RE: Work Plan Addendum for Additional Site Assessment

Former 76 Service Station No. 7124
10151 International Boulevard
Oakland, California
SECOR Project # 77CP.01634.43.1009

Subject: Fuel Leak Case No. RO0002444 and Geotracker Global ID T0600173591, Unocal 7124, 10151 International Boulevard, Oakland, CA

FORMER 76 STATION NO. 7124 10151 INTERNATIONAL BLVD. OAKLAND, CALIFORNIA		SITE PLAN WITH PROPOSED SOIL BORING AND WELL LOCATIONS		FIGURE: 2
	JOB NUMBER: 77CP.01634.41	DRAWN BY: DWR	CHECKED BY: BC	APPROVED BY: RB	DATE: 7/3/08

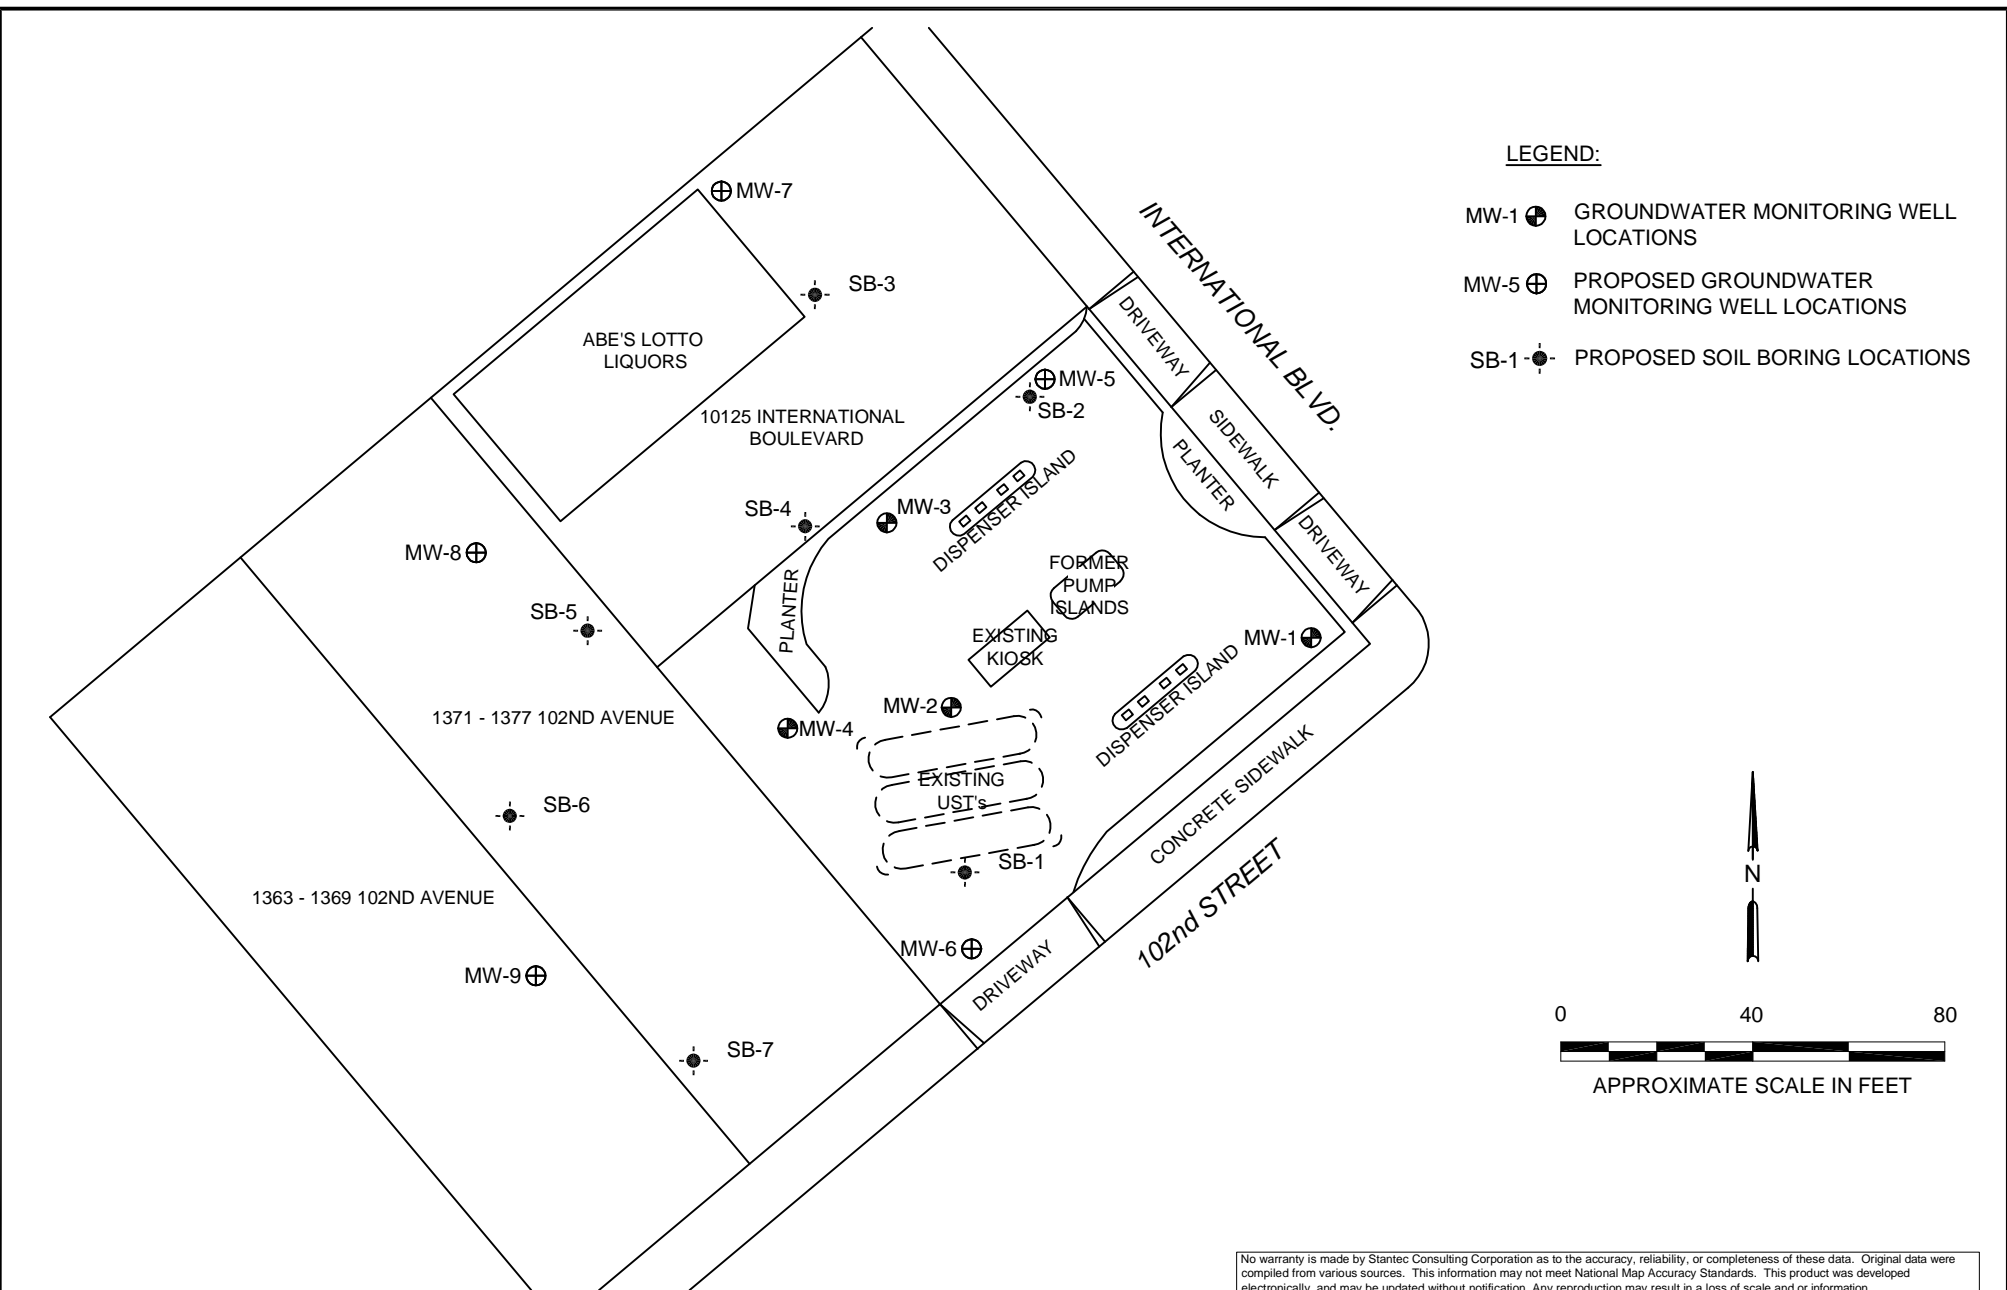
1. **Lateral Soil and Groundwater Characterization.** Before installing permanent monitoring points, we recommend that you assess the lateral extent of the soil and groundwater plumes by advancing exploratory borings in your proposed boring locations. We request that soil samples be collected and analyzed at areas of obvious contamination, the soil/groundwater interface, at each lithology change, or at a minimum of five-foot intervals. We recommend that you obtain at least two soil samples that are below the detection limits to define the vertical extent of contamination in soil. We request that this boring be continuously cored to obtain lithologic information to locate your screen intervals and to add and update your previously submitted cross-sections.

- **July 10, 2008** – Work plan addendum - Abbreviated work plan addendum with new proposed boring location map and a letter stating planned discrete sampling method, revised quarterly monitoring reports with correct north arrow and new maps of remaining quarterly monitoring reports with incorrect north arrow.

The proposed scope of work includes the advancement of two on-site soil borings (SB-1 and SB-2) and five off-site soil borings (SB-3 through SB-7), as shown on Figure 2.

Soil Borings. Seven soil borings (SB-1 through SB-7) will be advanced at the locations shown on Figure 2. The soil borings will be advanced using 8-inch diameter dual-tube direct push drilling equipment. Each boring will be continuously cored to a total depth of 30 feet bgs. Field and laboratory procedures are provided in Attachment 2.
